Subject: **SBWR Test Program**

Reference: Purdue Testing Meeting, GIRAFFE Testing Program RAIs,
October 1, 1993

Requests for Information by Purdue University prior to
meeting on October 1, 1993.

GE ANSWERS TO PURDUE UNIVERSITY QUESTIONS ON SBWR SYSTEMS

R.W.C.U./S.D.C.

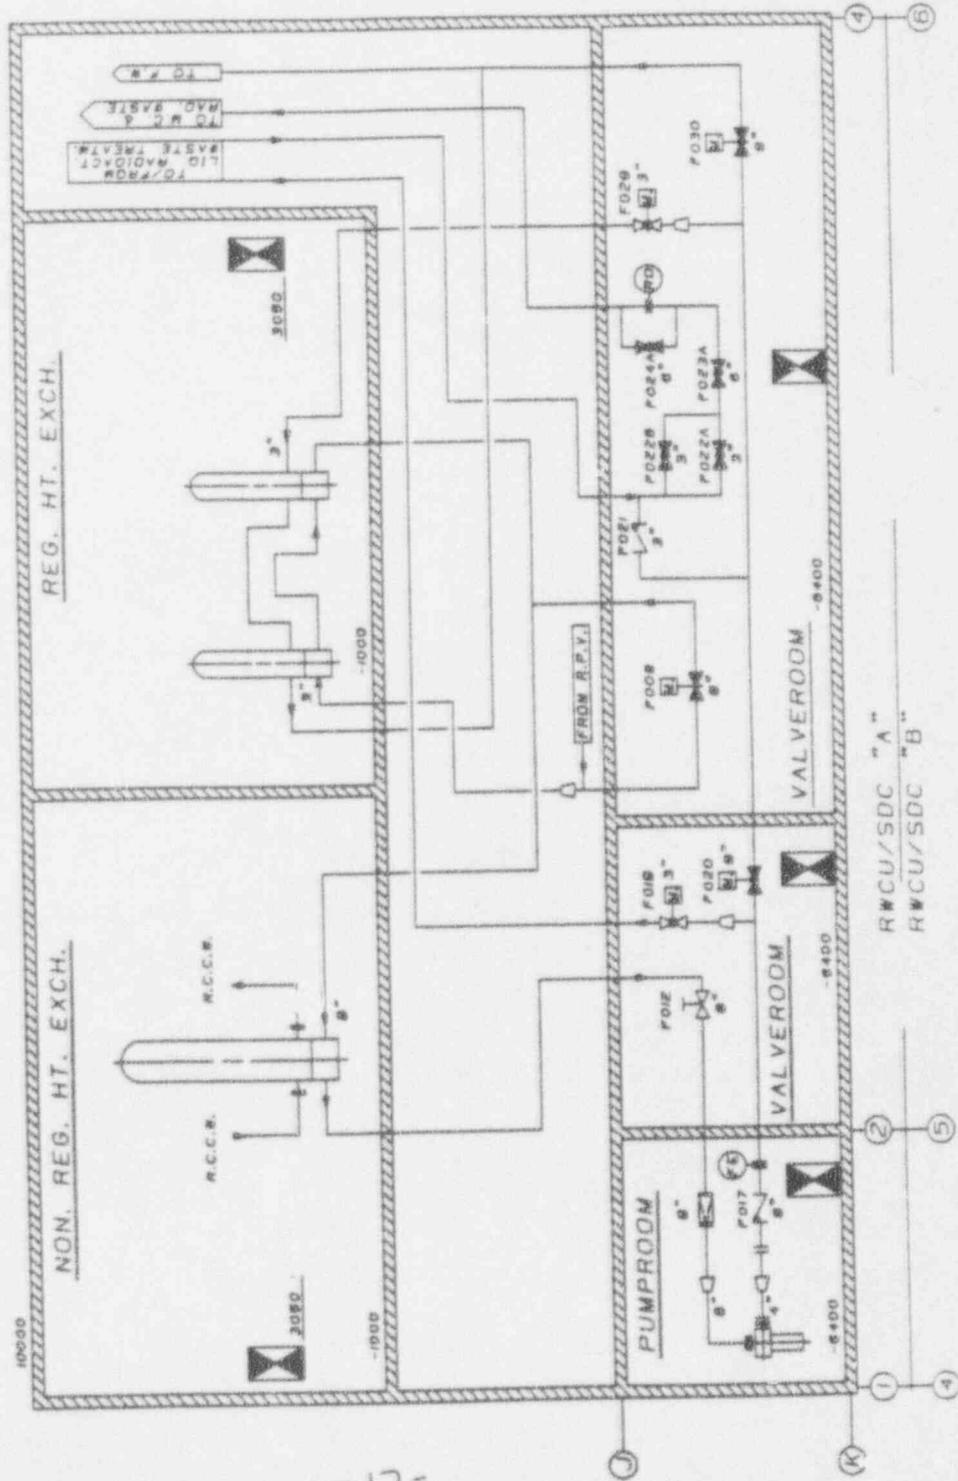
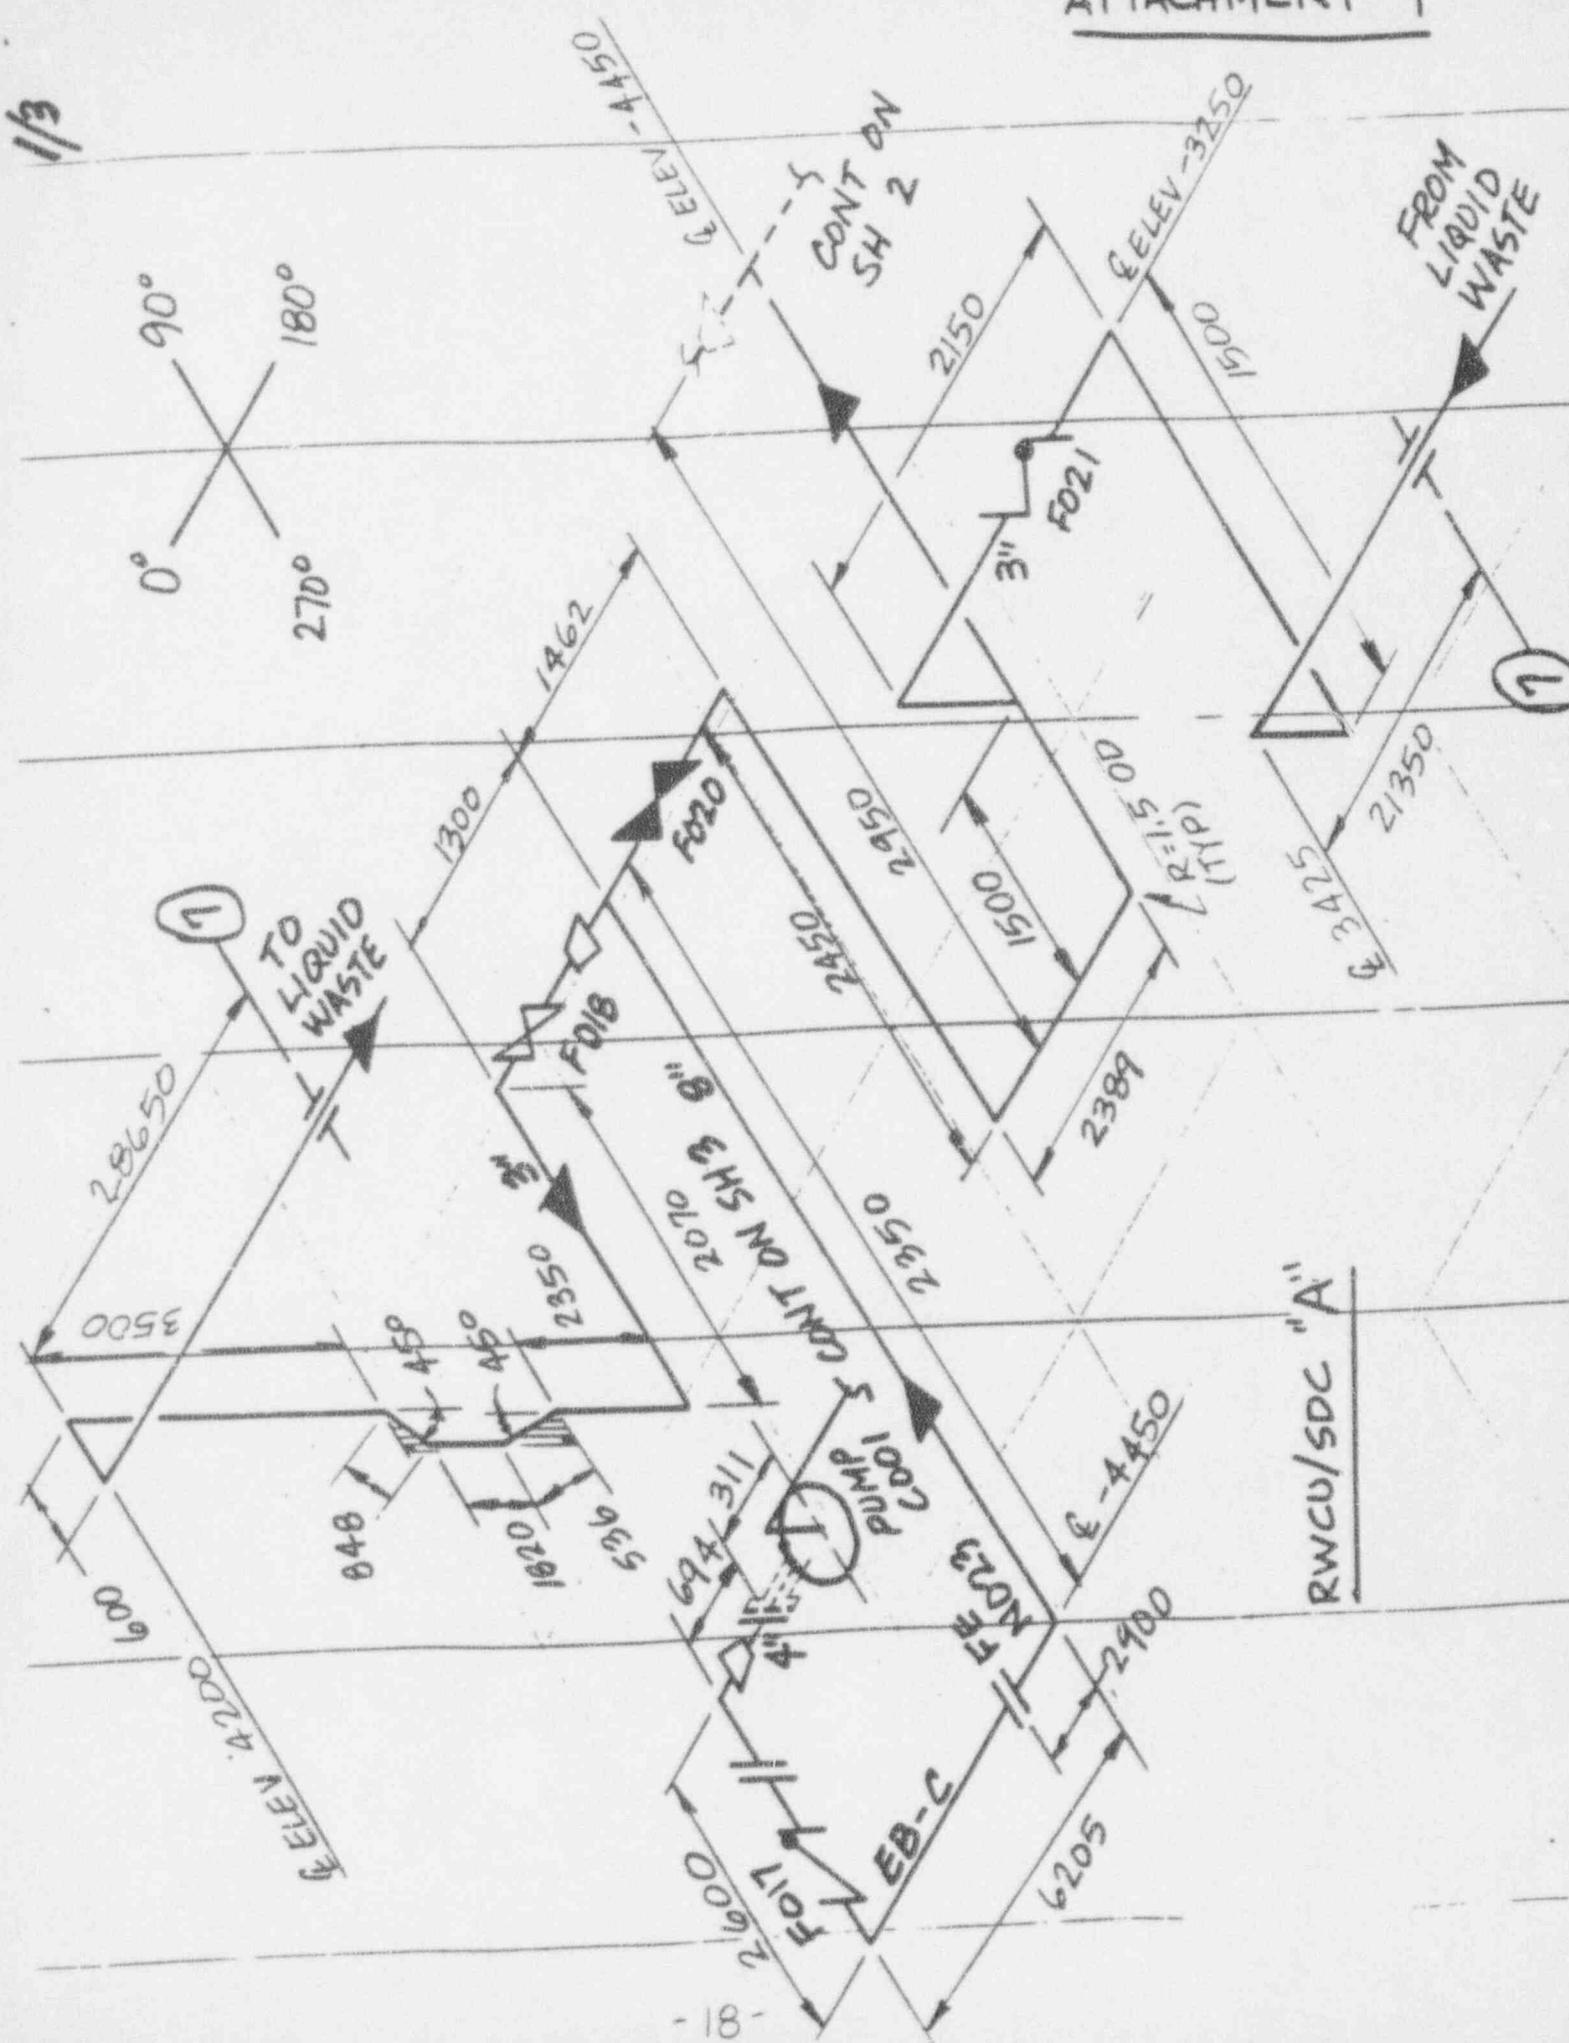
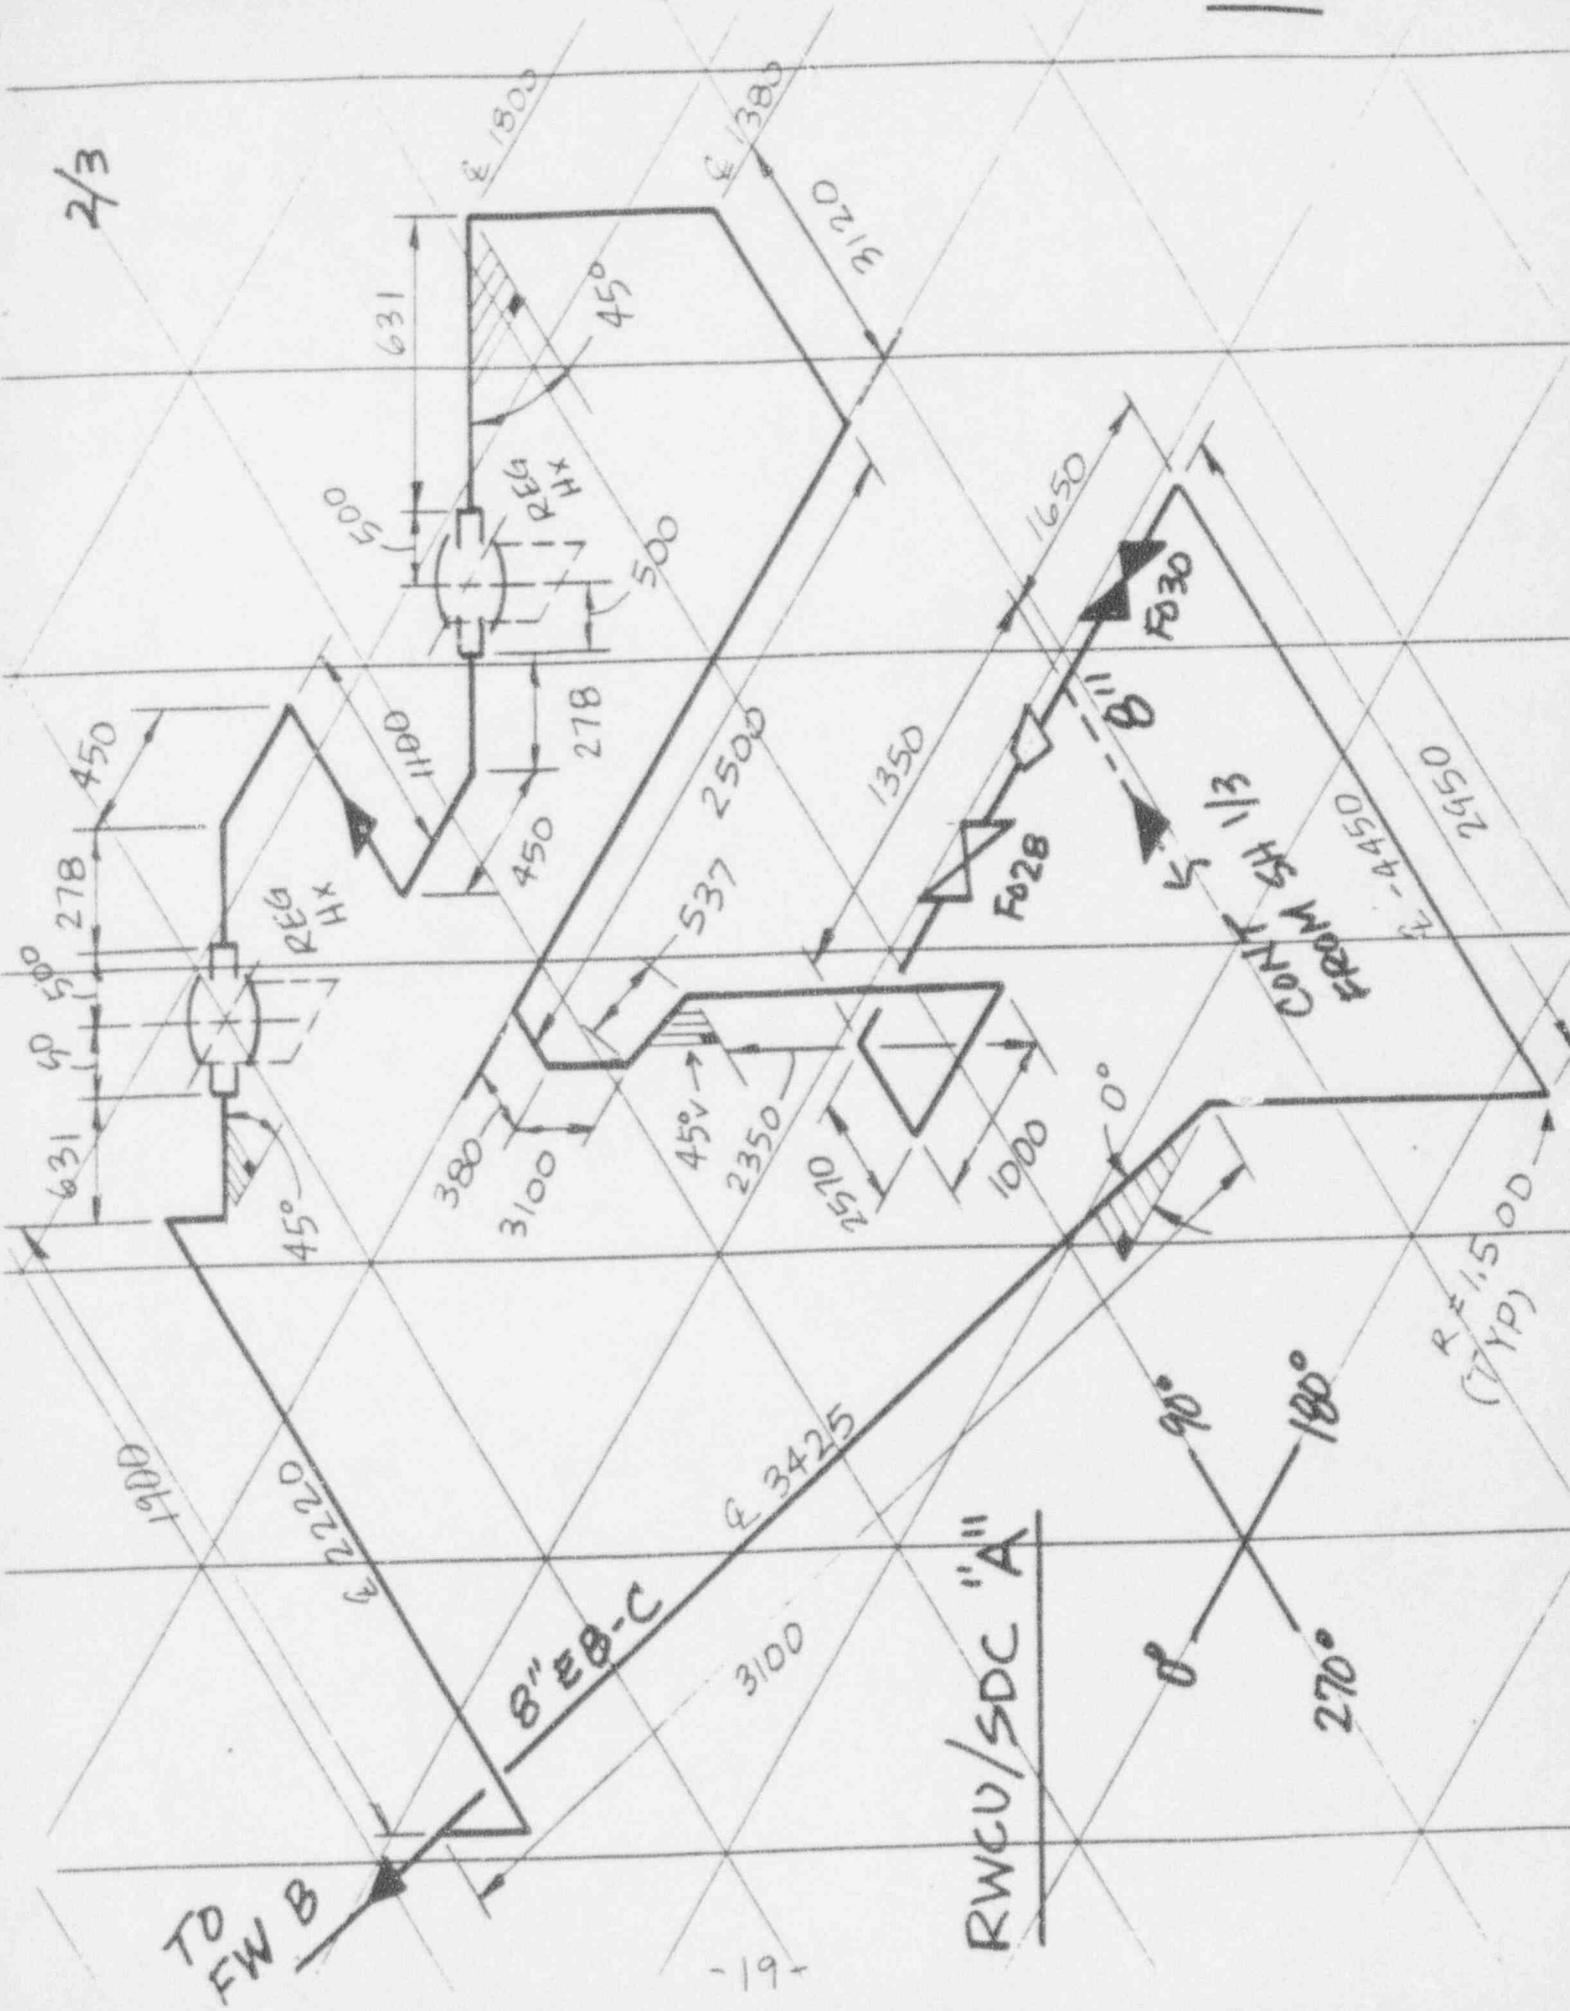
6. Need isometric drawings for pipings of the following auxiliary systems :
- a. Reactor water cleanup system/Shut Down System
 - b. Control Rod Drive System

- a. RWCU/SDC system drawings attached.
